CITY PLANNING COMMISSION

- APPLICATION:
1. Environmental Determination
 2. Tentative Map to divide 15± vacant acres into 67 single family lots in the Single Family (R-1) zone.
 3. Subdivision Modification to create lots with double street frontage.

LOCATION: Southwest corner of Main and Norwood Avenues

APPLC. NO. P83-315

TENTATIVE MAP OF
GLENWOOD PARK #6
 CITY OF SACRAMENTO CALIFORNIA

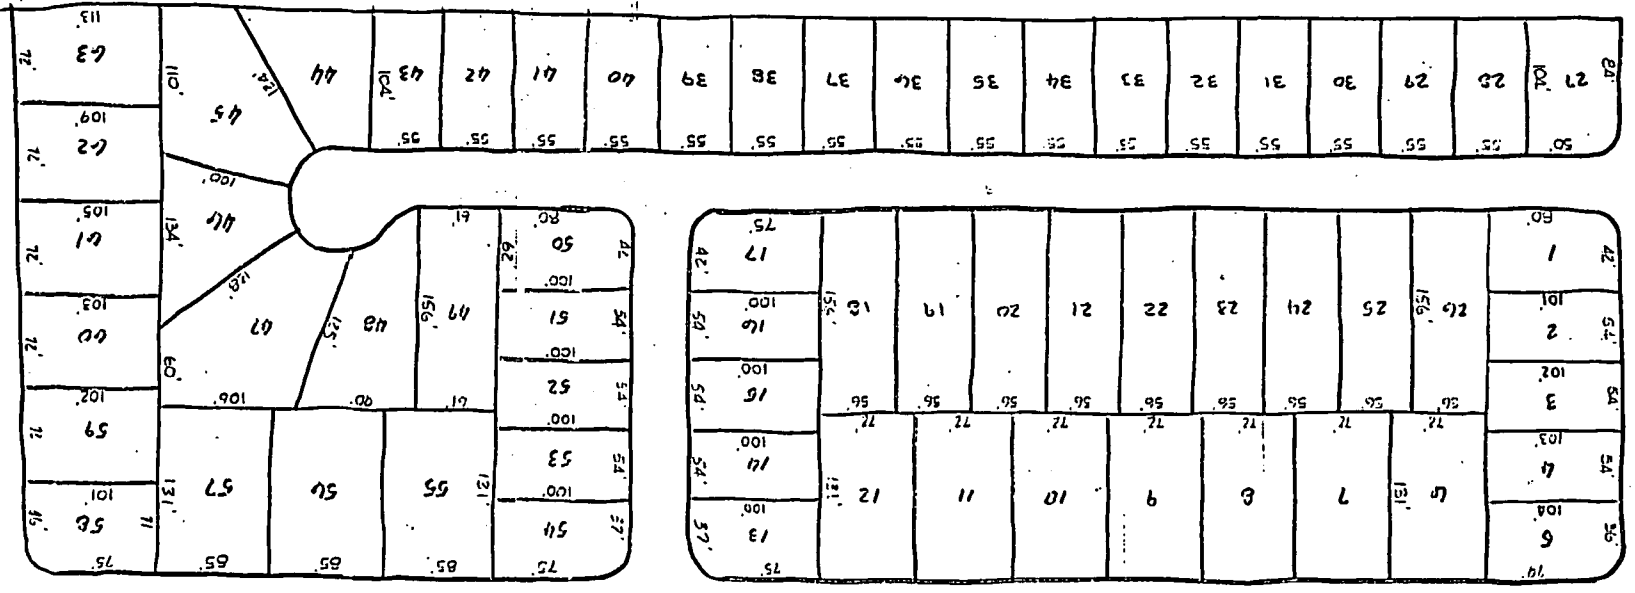
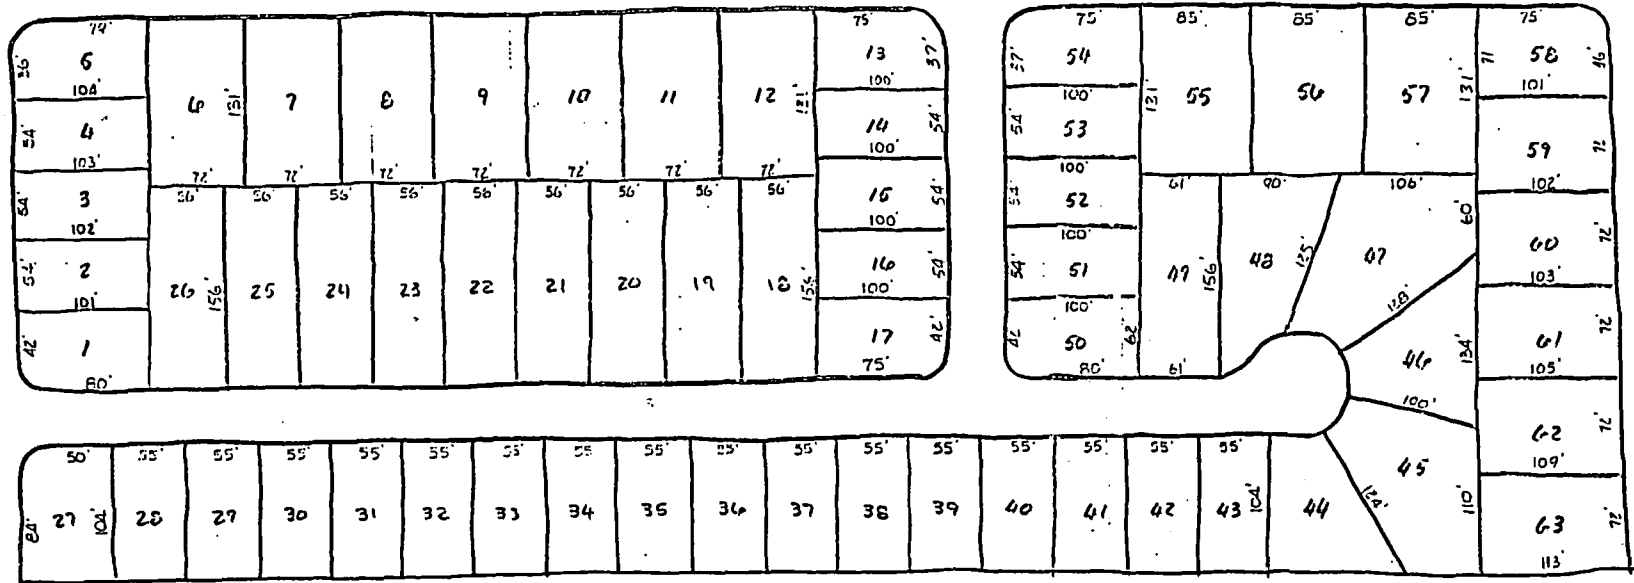
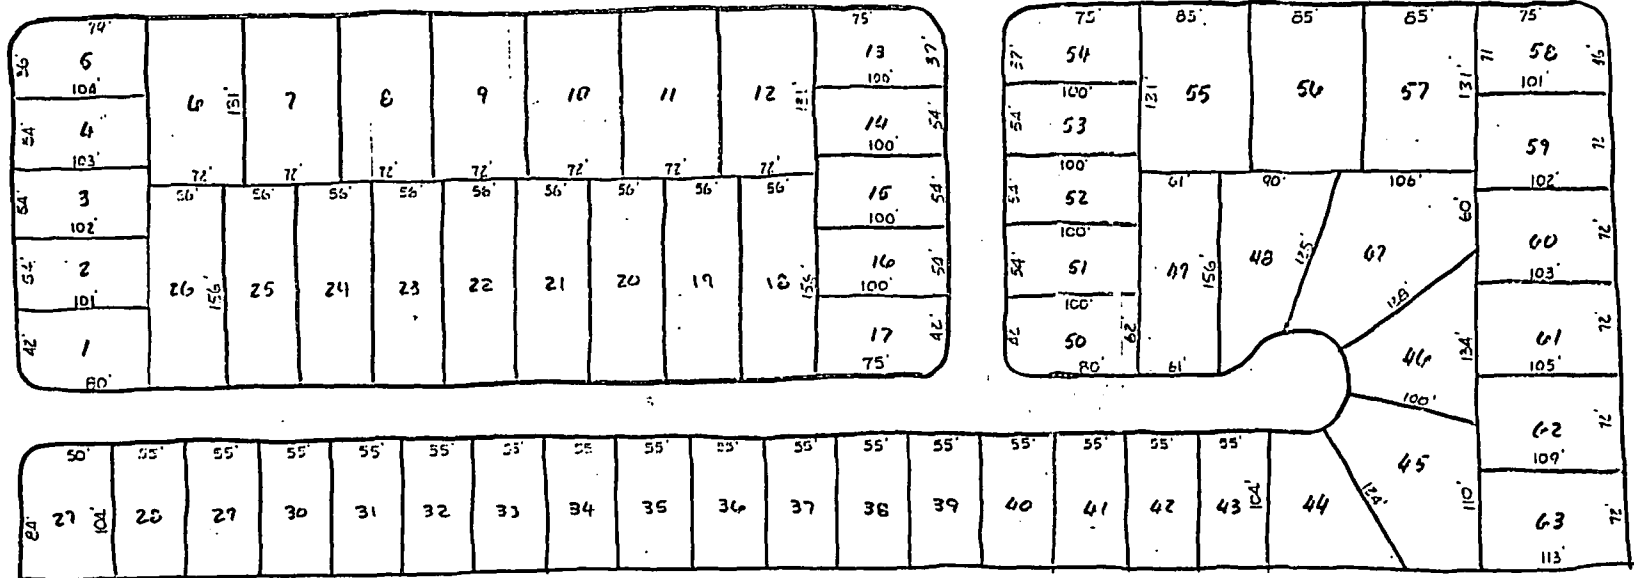
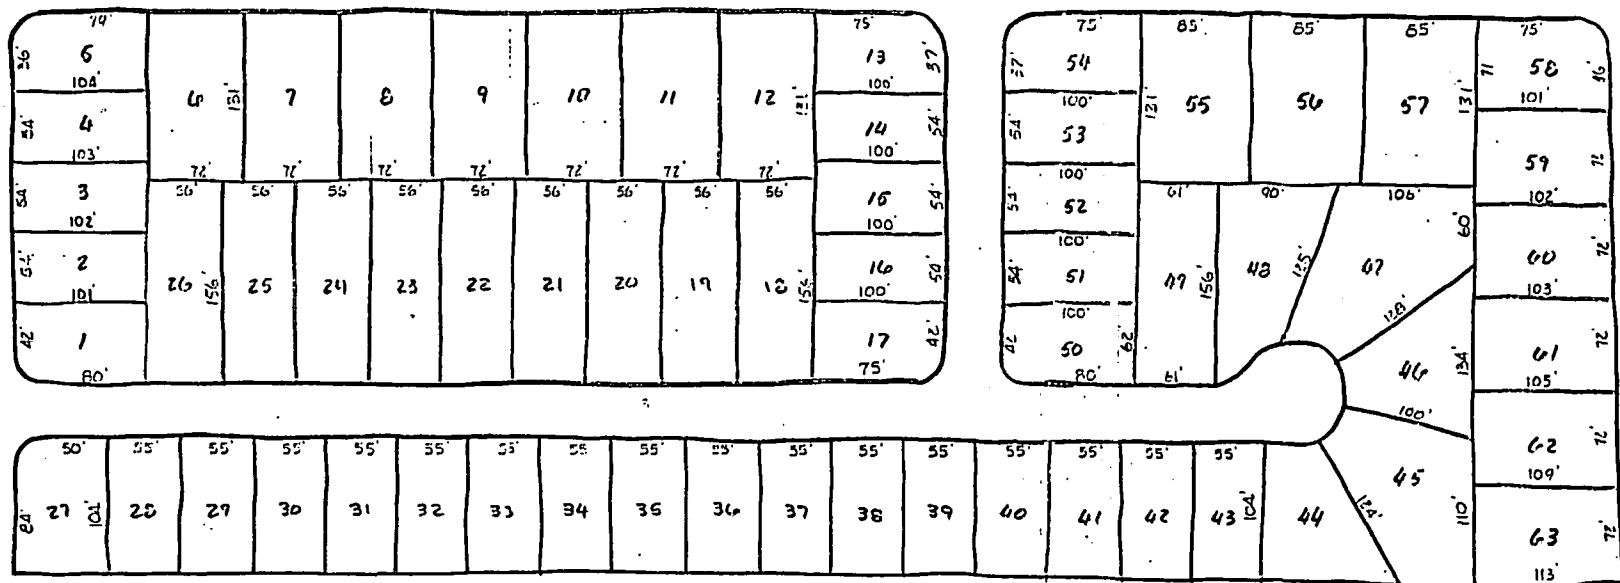
2. The subdivision, as proposed, has six lots with double street frontage (Lots 9, 10, 18, 19, 36 and 37) and seven lots with frontage on Norwood Avenue (Lots 42-48), a major street. Because these types of lots are undesirable, staff had suggested to the applicant that the project be redesigned to eliminate the lots with double street frontage and to include multiple family units on the eastern portion of the site. The multiple family units would eliminate the frontage lots on Norwood Avenue. The applicant, however, has completed improvement plans for the site based on the previously approved tentative map and prefers not to revise the map. While the proposed map is not staff's preferred design for the site, it is consistent with the zoning and community plan designation for the site. Staff therefore recommends that a six-foot high masonry wall be placed along the south side of Main Avenue to prevent access to Lots 9, 10, 18, 19, 36 and 37 from the street. The design and materials of the wall shall be subject to the review and approval of the Planning Director.

3. The proposed tentative map achieves only a 61% north/south lot orientation, whereas the General Plan requires an 80% north/south lot structure orientation. The applicant shall designate and place on the final map those structures and/or lots which will meet the required 80% south orientation to the satisfaction of the Planning Director.

4. The proposed map indicates staggered front setback lines along Municipal Avenue from 20 to 30 feet. While staff approves of the use of staggered setbacks, as it helps to break up a possible "row" effect along the south side of the street, staff reminds the applicant that the minimum front yard setback is 25 feet. Those lots with substandard setbacks will need to be revised before final map approval.
5. The Planning and Community Services Departments have determined that .9983 acres of land are required for parkland dedication purposes and that fees are to be charged in lieu of the required dedication. The subdivider shall submit to the City an appraisal of the land to be subdivided. The appraisal shall be dated and submitted no more than 90 days prior to the filing of the final map.

- a. Provide standard subdivision improvements pursuant to Section 40.811 of the City Code;
- b. Prepare a sewer and drainage study for the review and approval of the City Engineer;

- c. Name the streets to the satisfaction of the Planning Director;
- d. Pursuant to City Code Section 40.1302 (Parkland Dedication), the applicant shall submit to the City an appraisal of the property to be subdivided and pay the required parkland dedication in-lieu fees. The appraisal shall be dated not more than 90 days prior to the filing of the final map;

- e. Pursuant to City Code Section 40.319-1, the applicant shall indicate easements on the final map to allow for the placement of centralized mail delivery units. The specific locations for such easements shall be subject to review and approval of the City Engineer after consultation with the U.S. Postal Service;

- f. The applicant/developer shall designate and place on the final map those structures and/or lots which will meet the required 80% south orientation (including solar access) to the satisfaction of the Planning Director;

- g. Dedicate 45-foot half-section for Norwood Avenue;
- h. Dedicate 60-foot half-section for Main Avenue;
- i. Existing excess right-of-way at Norwood and Main Avenues to be abandoned upon completion of new improvements;

- j. Provide for a six-foot solid masonry wall along Main Avenue. The design and materials of this wall shall be subject to the review and approval of the Planning Director;

- k. Dedicate rights of access to Main Avenue for the lots adjacent to Main Avenue to the City.

TYPICAL PLOT PLAN ALONG MAIN AVENUE

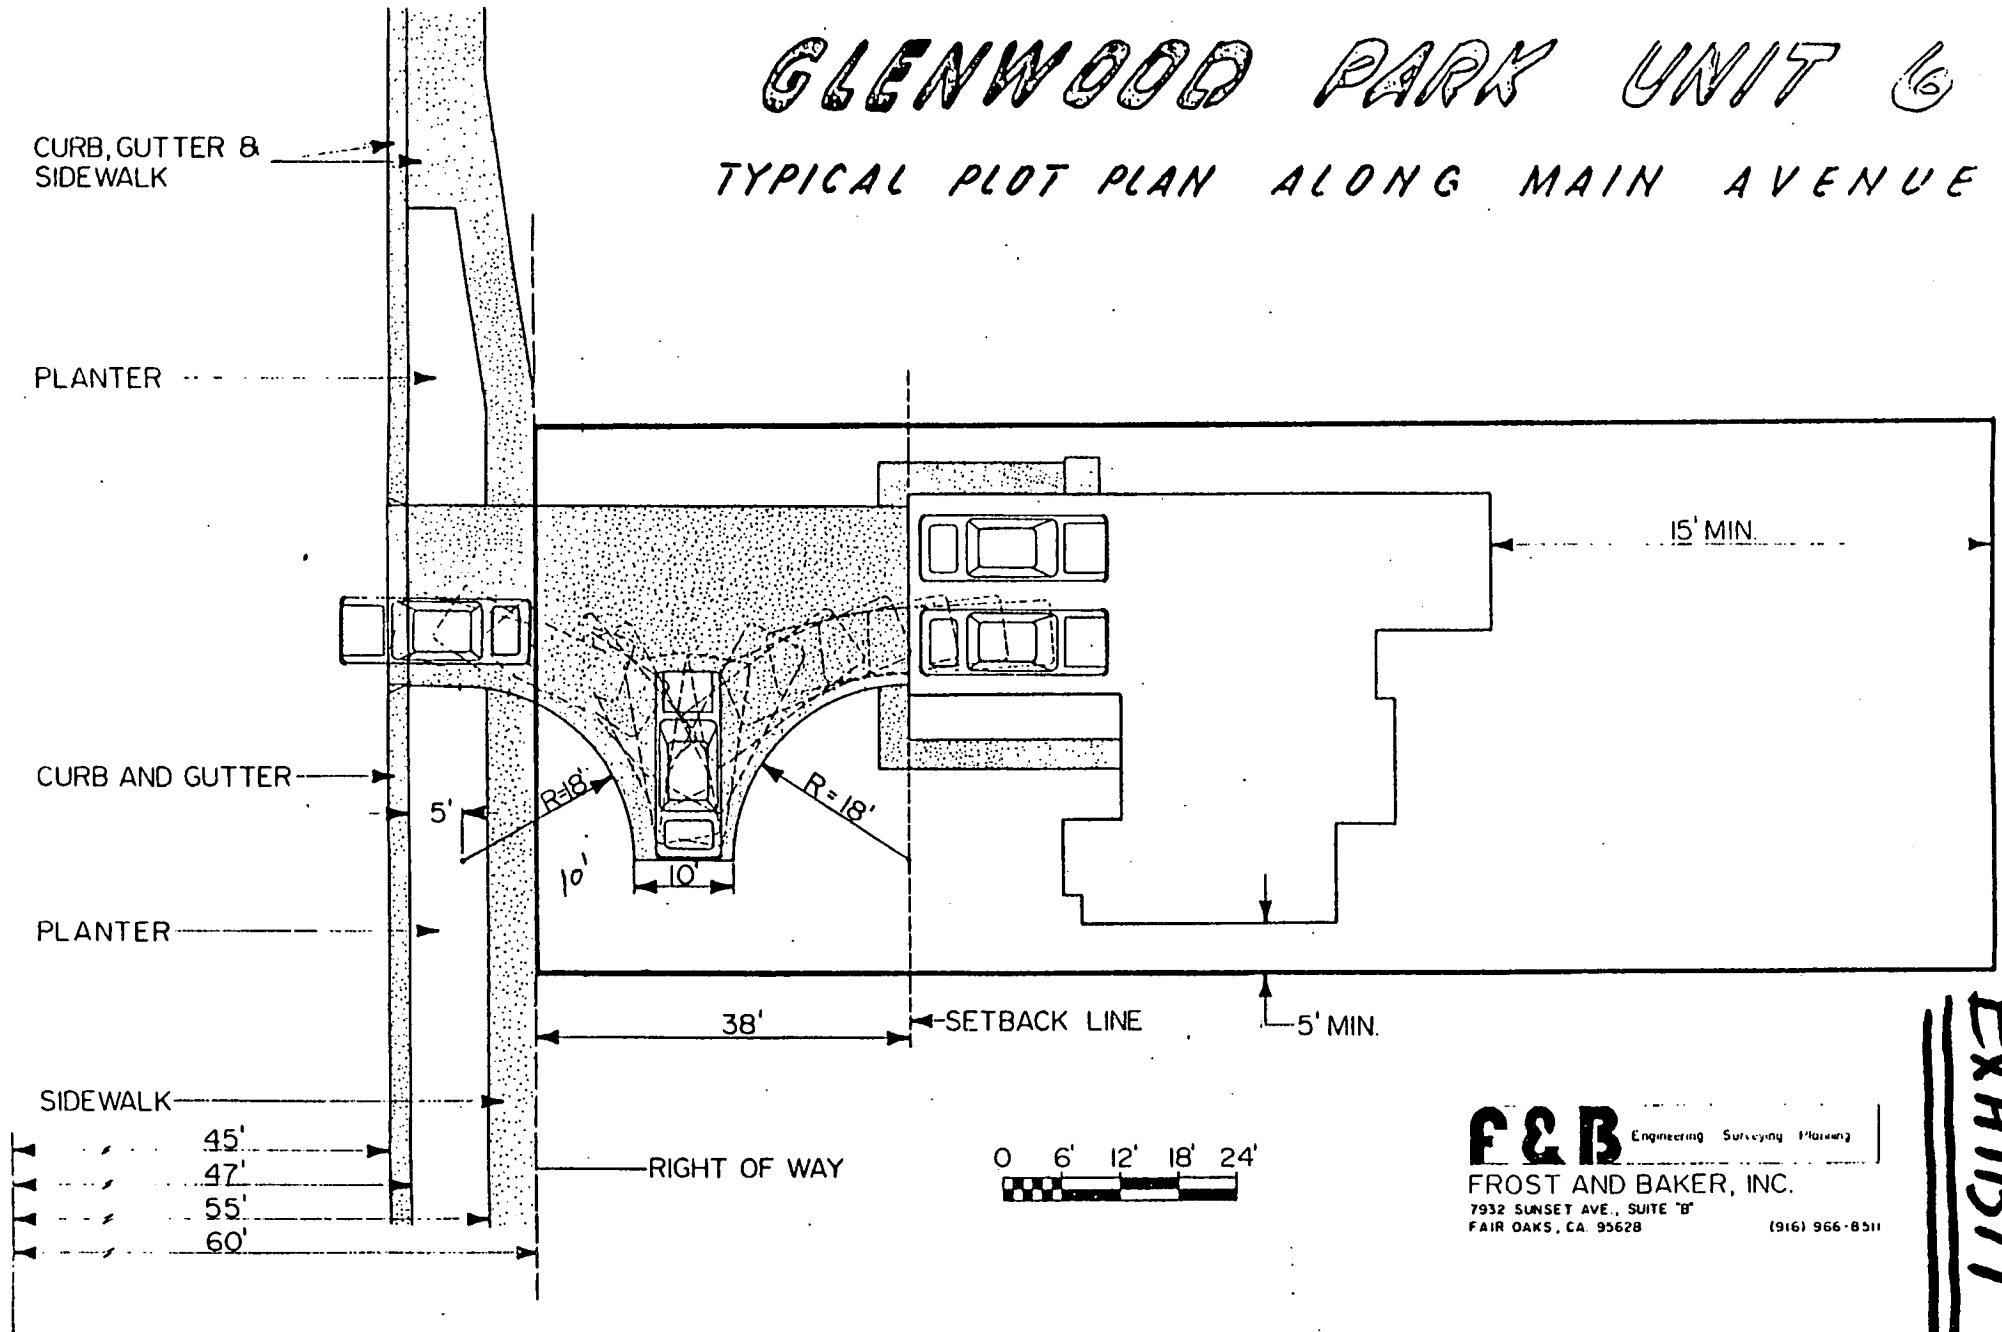
10. Provide for a six-foot solid masonry wall along Main Avenue. The design and materials of this wall shall be subject to the review and approval of the Planning Director;
